ZONING COMMISSION

AGENDA

Wednesday, April 12, 2023

Zoning Map Amendment & Site Plan

EXHIBIT "C" SITE PLAN
FOR
COTTAGES AND VILLAS AT MARYS CREEK
BEING 57.0142 ACRES
OUT OF THE
CRESWELL, LB SURVEY, ABSTRACT NO. 367
IN THE
CITY OF FORT WORTH, TARRANT COUNTY, TEXAS

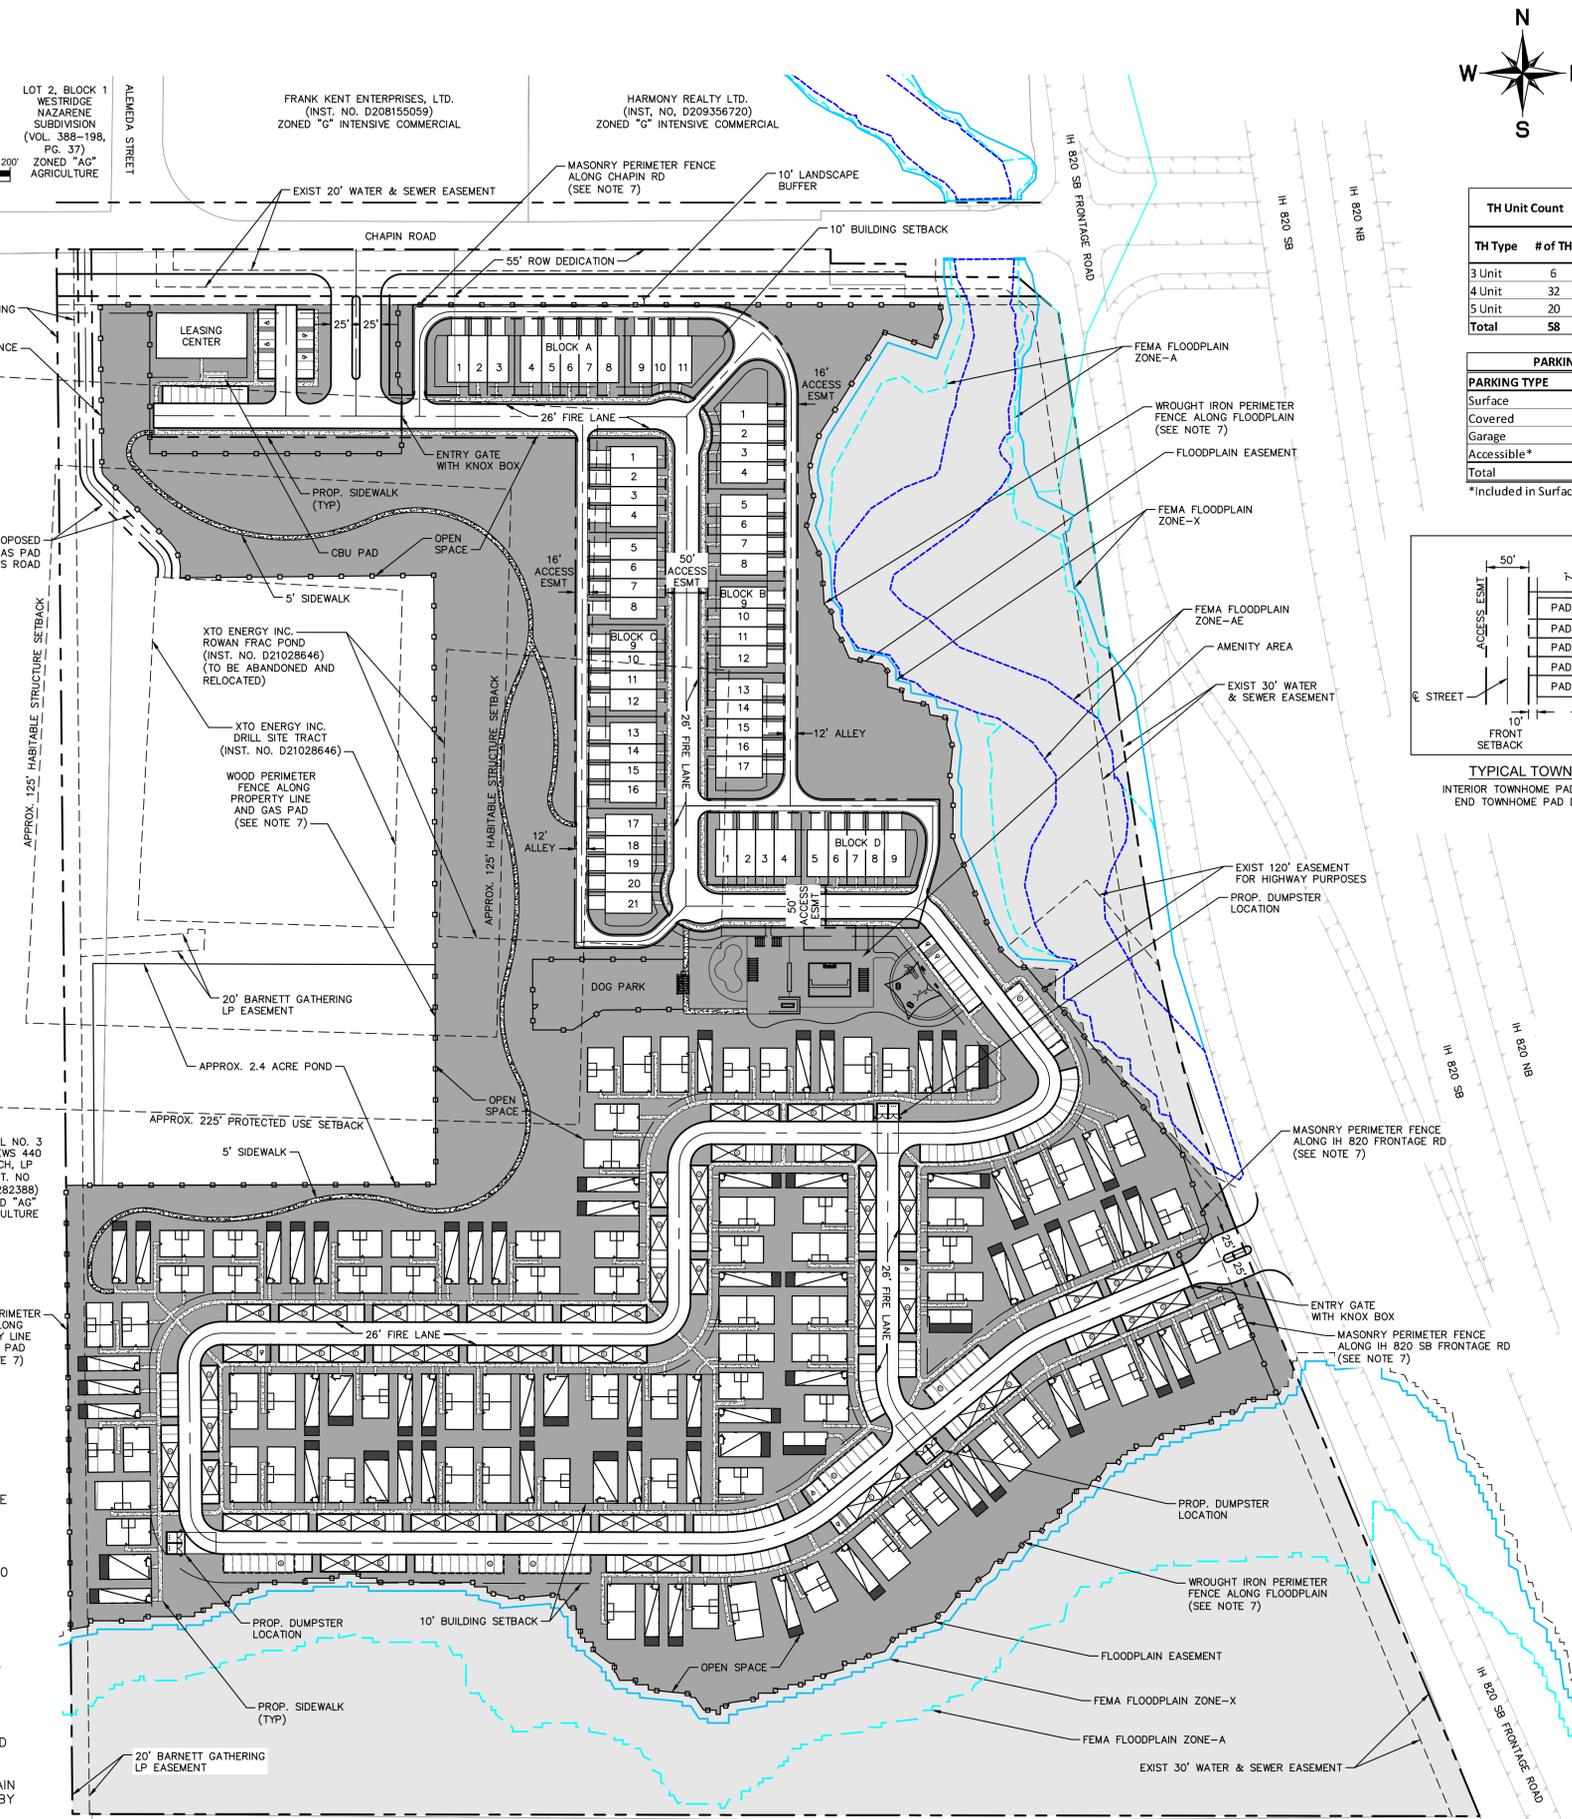
- Missing case number and address
- Should be called “development standards”, not “deviations”
- “Proposed PD-CR” rather than “Proposed PD”
- Missing listing of development standards (waivers) at the top
- Missing density (units per acre), bufferyard & screening, landscaping, and urban forestry
- Provide parking counts for required and provided in table

- Eliminate distinctions on Open Space types (easement, floodplain, amenity)
- Add gas well acreage
- Table should show total site acreage, less gas well acreage and row dedication
- Include open space expressed as acreage as well as percent of site (less gas & row or ~48 ac)
- Revise Summary table:
 - Remove developable acreage

- Revise density to 6.7 DU/acre (based on 374 units on 55.7 acres)
- Density is calculated as total acreage minus any right of way dedications, or 57.0 less 1.3 = 55.7

- Remove Open Space Summary Table from Site Plan
- Provide Separate Open Space Diagram exhibit with areas shaded that meet definition of Open Space in Section 9 of the City of Fort Worth Zoning Ordinance.

- Provide additional space for Director signature and date lines
- Add Case # reference ZC-22-156
- Rename "PD Development Plan" to "Site Plan"
- If parking is calculated per the Zoning Ordinance requirements (1 per bedroom plus 1 per 250 square feet of common area) that waiver/development standard could be eliminated. The less development standards the better.
